City of Parramatta	
File No:	DA/960/2022

SECTION 4.15 ASSESSMENT REPORT Environmental Planning & Assessment Act 1979

DA No:	DA/960/2022
Property:	Lot 23 DP 651527, MBC House, 188 Church Street, PARRAMATTA NSW 2150
Proposal:	Stage 1 concept proposal for a six storey cantilevered commercial extension atop the existing heritage listed Murrays building. The proposal will allow for the future part demolition of the heritage item including internal realignment, amendments to the shopfronts and part removal of the roof.
Date of receipt:	8 December 2022
Applicant:	G & J Drivas Pty Ltd And Telado Pty Ltd
Owner:	G & J Drivas Pty Limited and Telado Pty Ltd
Property owned by a Council employee or Councillor:	The site is not known to be owned by a Council employee or Councillor
Political donations/gifts disclosed:	None disclosed on the application form
Submissions received:	Three
Recommendation:	Refusal
Assessment Officer:	Paul Sartor

Figure 10 - Proposed northern elevation

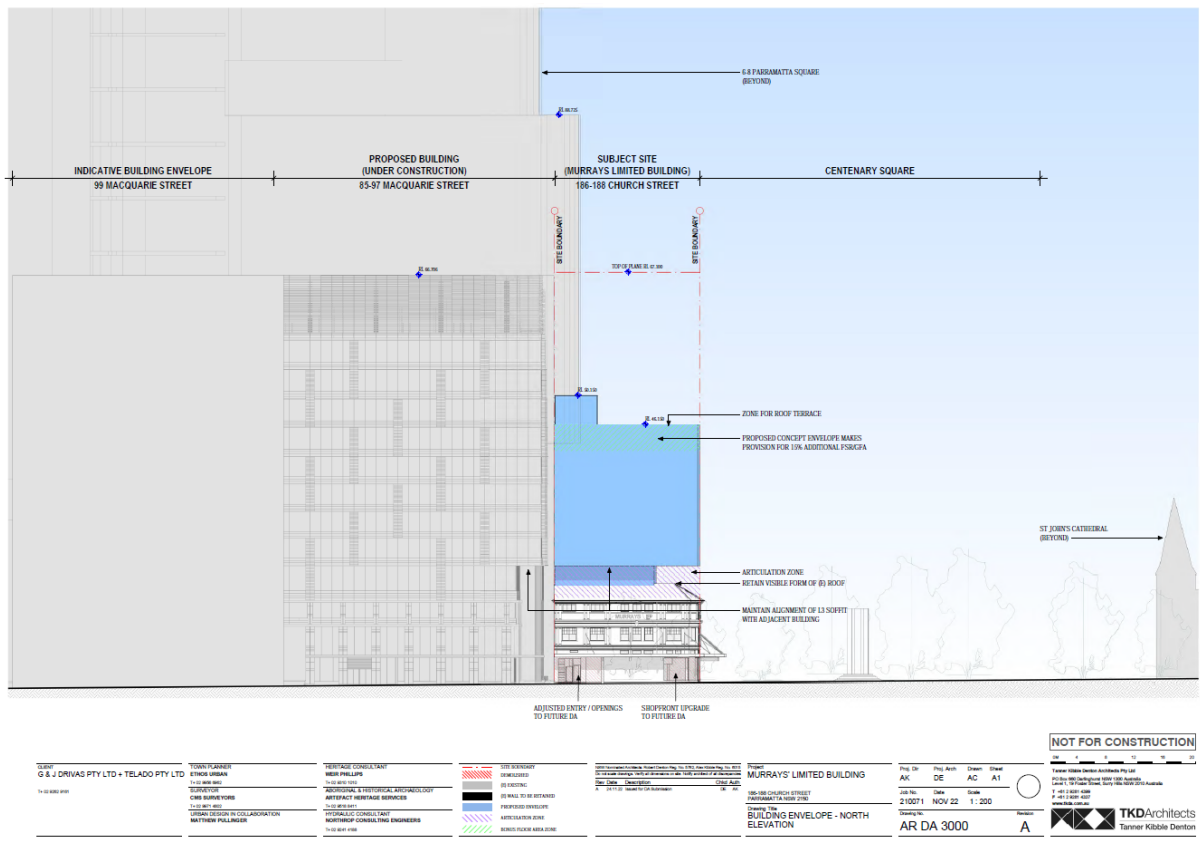
- Similarly, while the Panel can understand how the form and scale of the proposal has been generated, it cannot support the massing as proposed. Hovering a large rectilinear prism above a relatively low scaled hipped roof built form is a very crude manner in which to enlarge an existing building – especially a building that has been added to before. Its alignment with walls below would surely ask, what role does the roof have in the resultant composition? Nor does the proposed addition adequately address the western façade of 85-97 Macquarie Street, which is clearly (and quite successfully) designed to look out over the MLB's existing roofscape.*

- The overshadowing of Parramatta's Town Hall forecourt draws attention to the fact that the proposal would overwhelm the front façade of Parramatta's key public building. This is an especially unfortunate outcome that cannot be supported.*

- The Panel notes that the massing now proposed is almost unchanged since the last DEAP meeting. This is despite issues being raised regarding the proposal's scale, interface with 85-97 Macquarie Street, impact on*

The Panel does not support the proposal, significant re-design is recommended to respond to the issues noted above.

Figure 12 - Proposed perspective from Church St/Macquarie St intersection

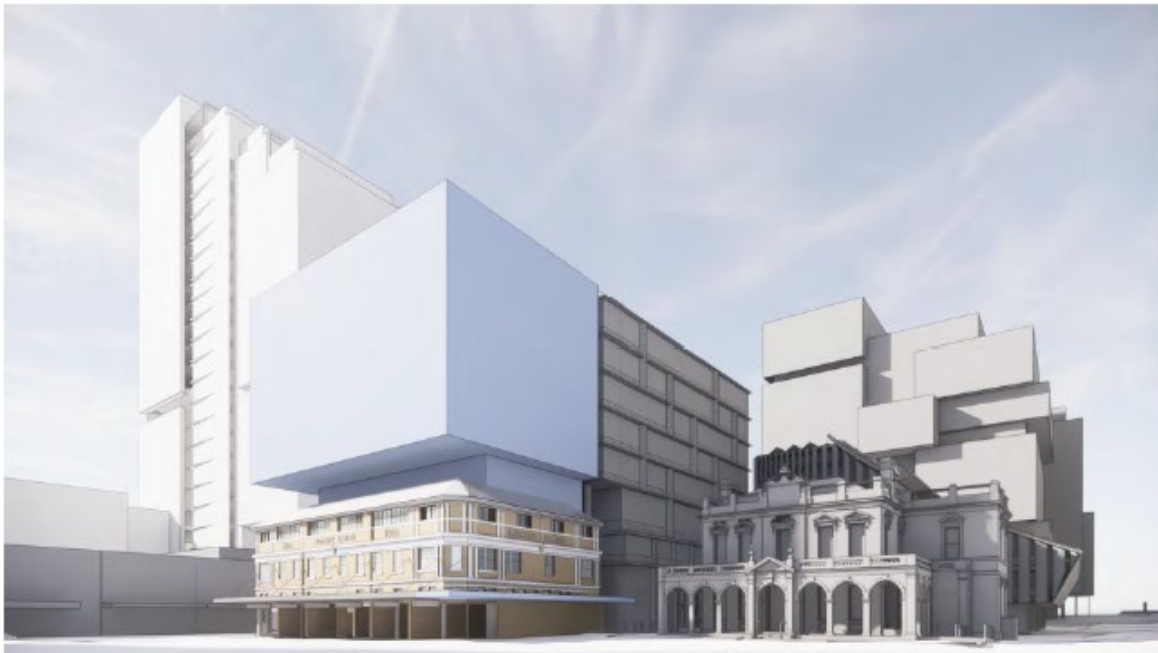
minimal setbacks to the boundary of the property which is overbearing on the existing heritage item and is a poor urban form outcome for the subject site and facing Centenary Square. The heritage impacts are discussed further in the assessment below.
